## UNCC - CID Phase II Wi-Fi

## BID ADDENDA No. 02

University of NC at Charlotte  
CID Phase II Wi-Fi

Clark Nexsen Comm. No. 5462  
State Project ID: 13-10724-01A  
Code: 41326 Item: 307

ALTERNATE #2  
KING BASEMENT,  
FIRST & SECOND  
FLOOR PLANS

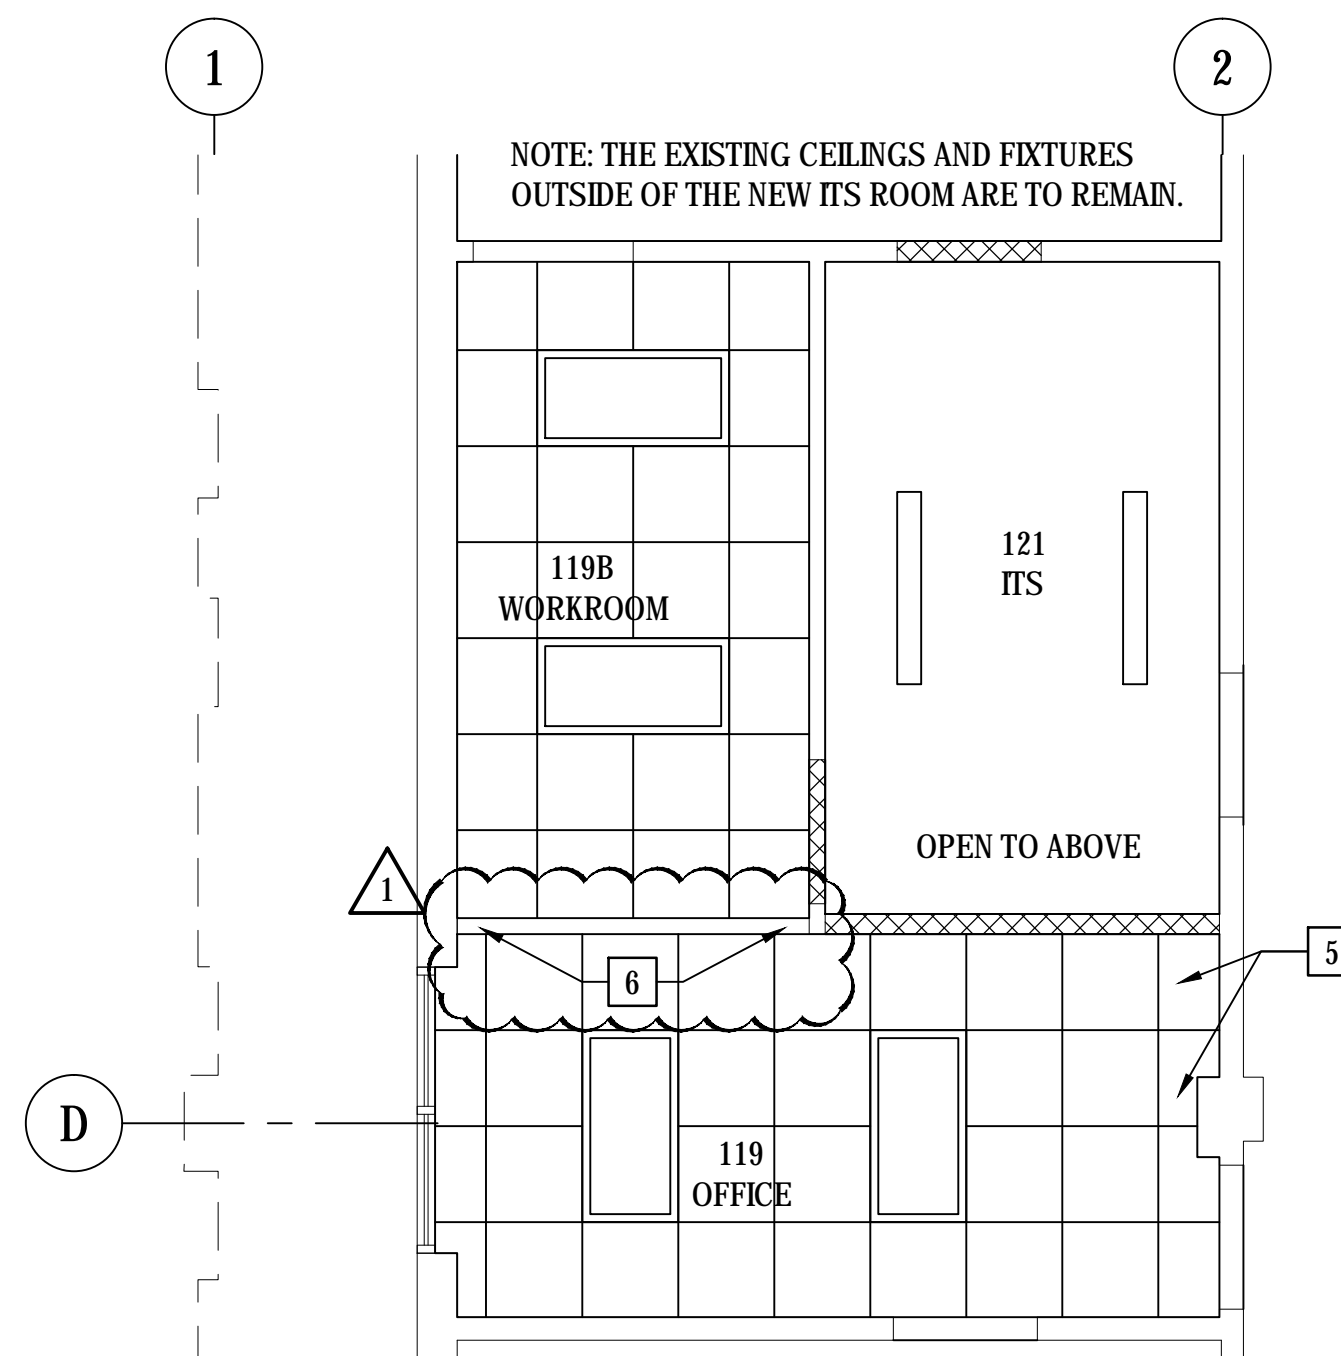
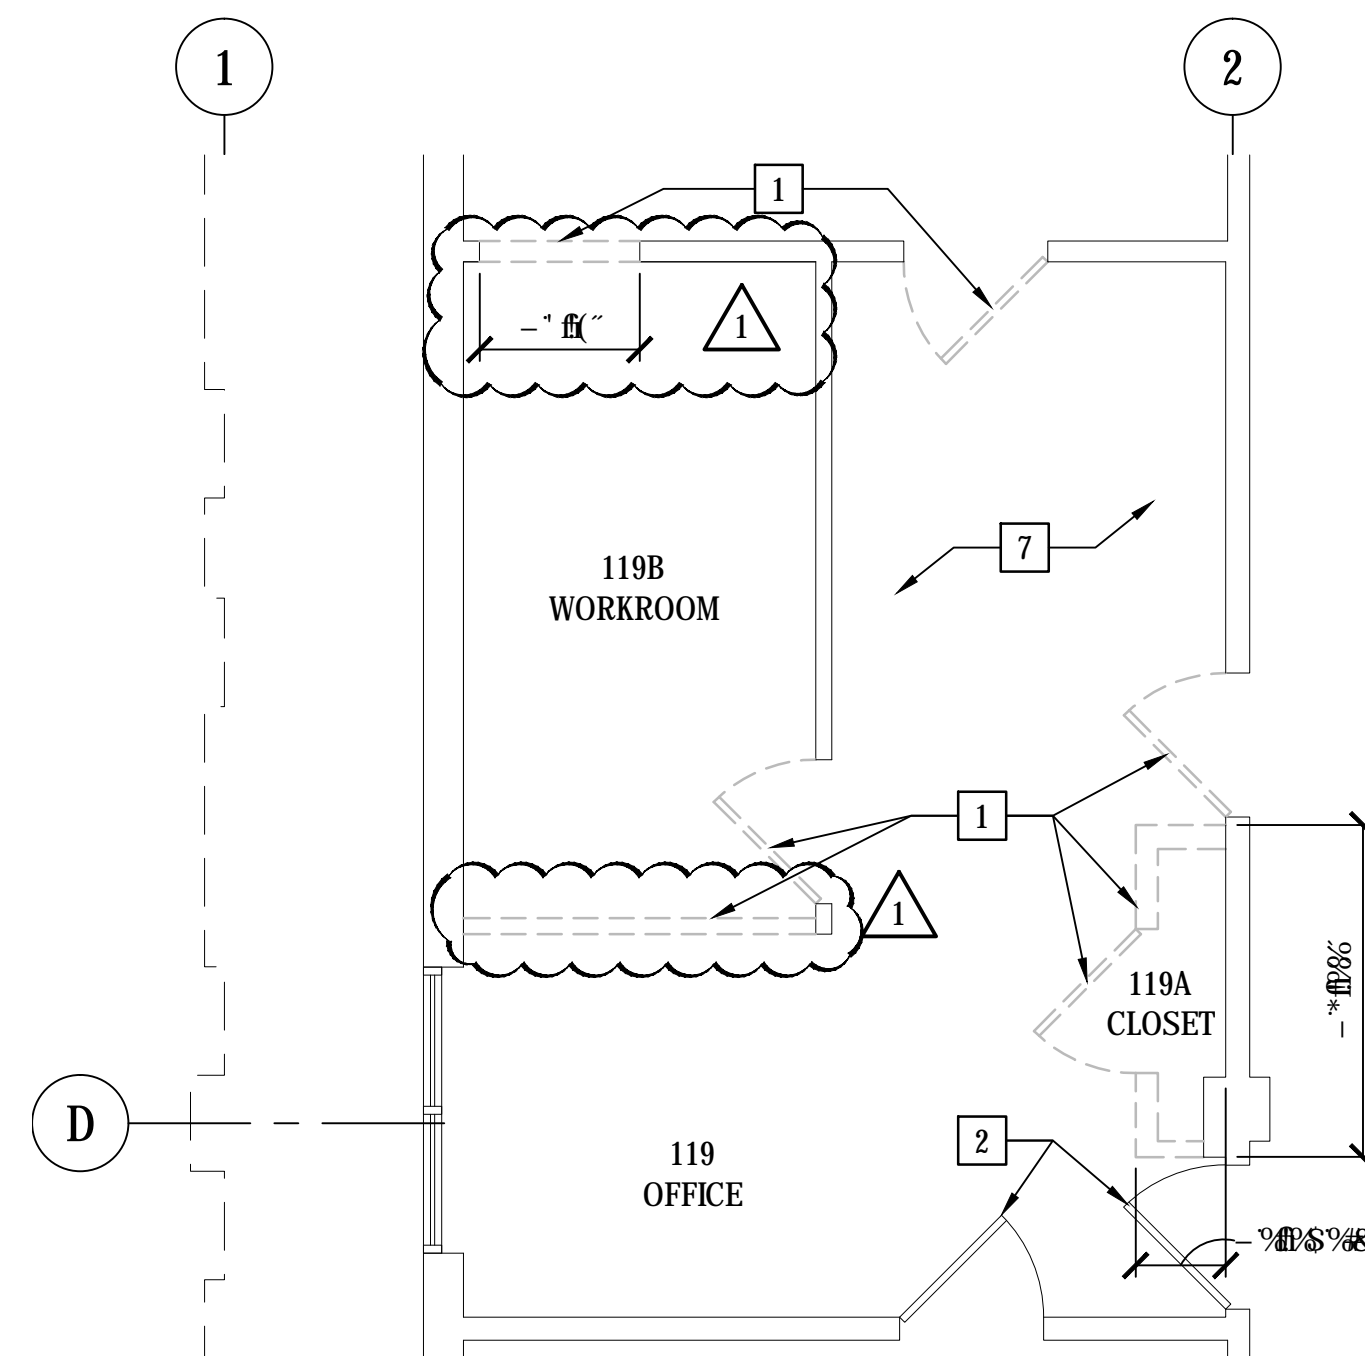
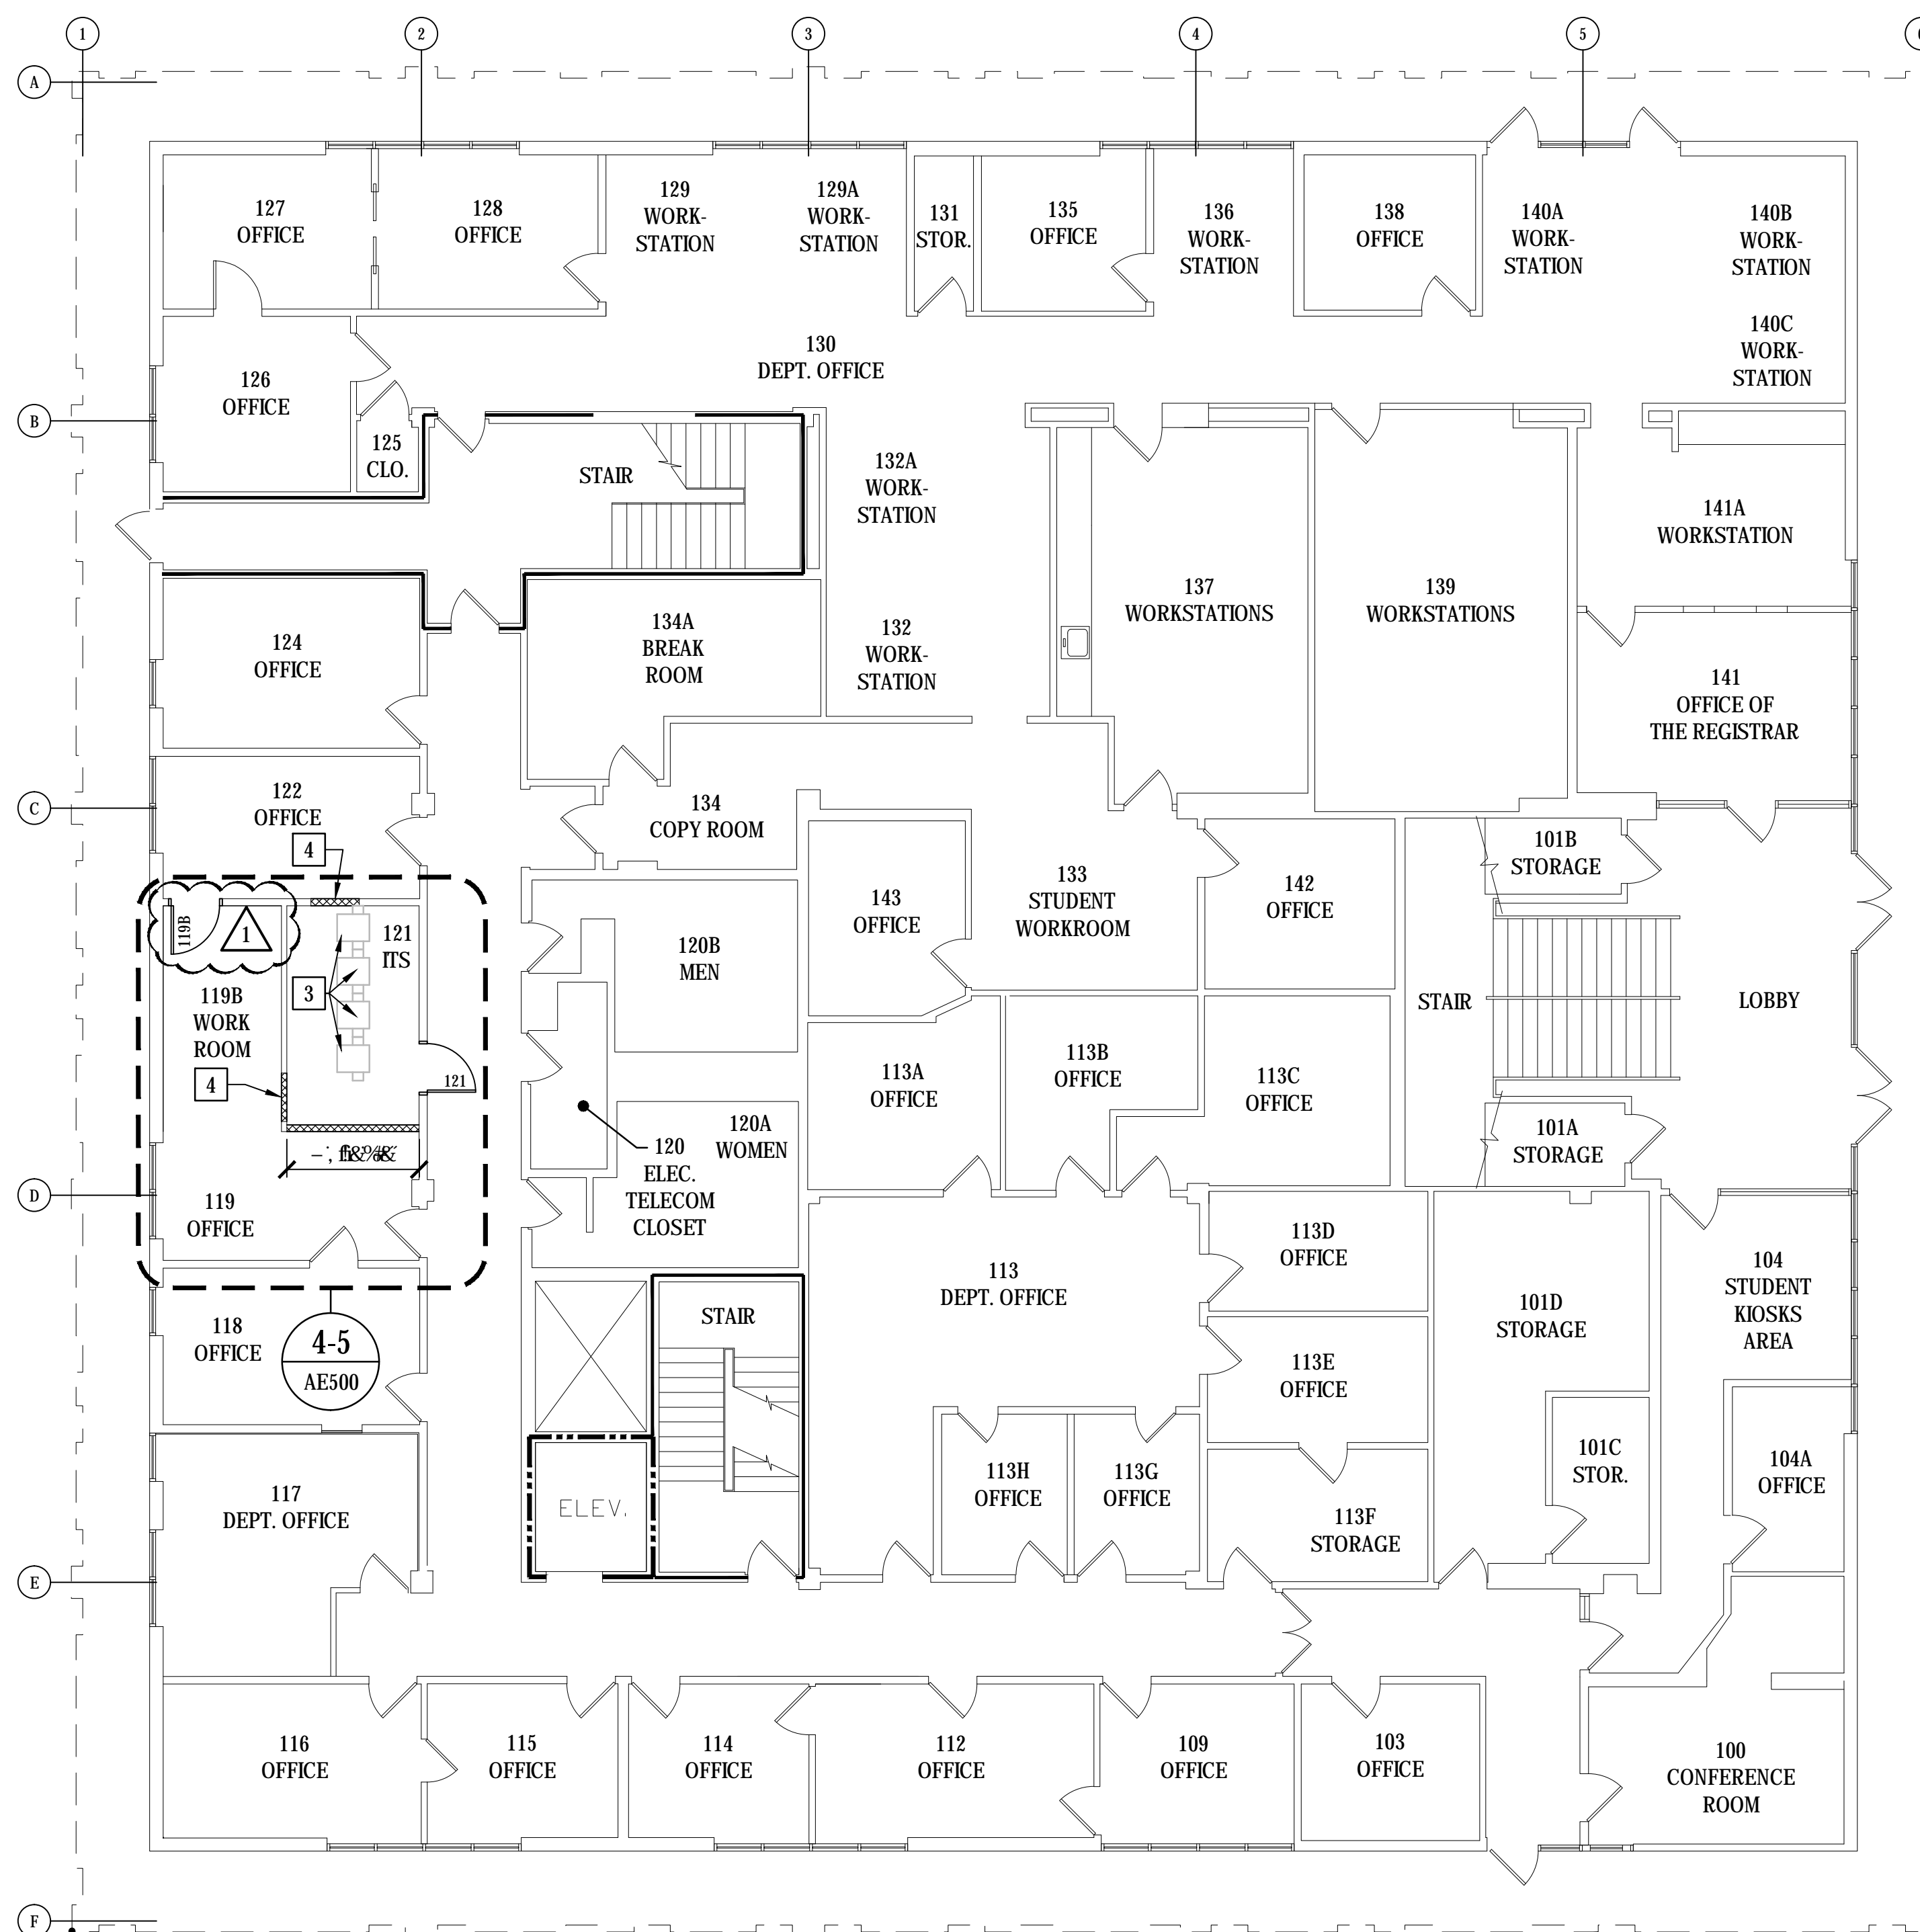
- Detail #4, ALTERNATE #2 KING – ROOM 121 has been renumbered to detail #3.
- Detail #5, ALTERNATE #2 KING – DEMOLITION PLAN has been renumbered to Detail #4.
- New work added to Work Room 119B.
- Construction Note #16 added to dual light switches in Office 119.
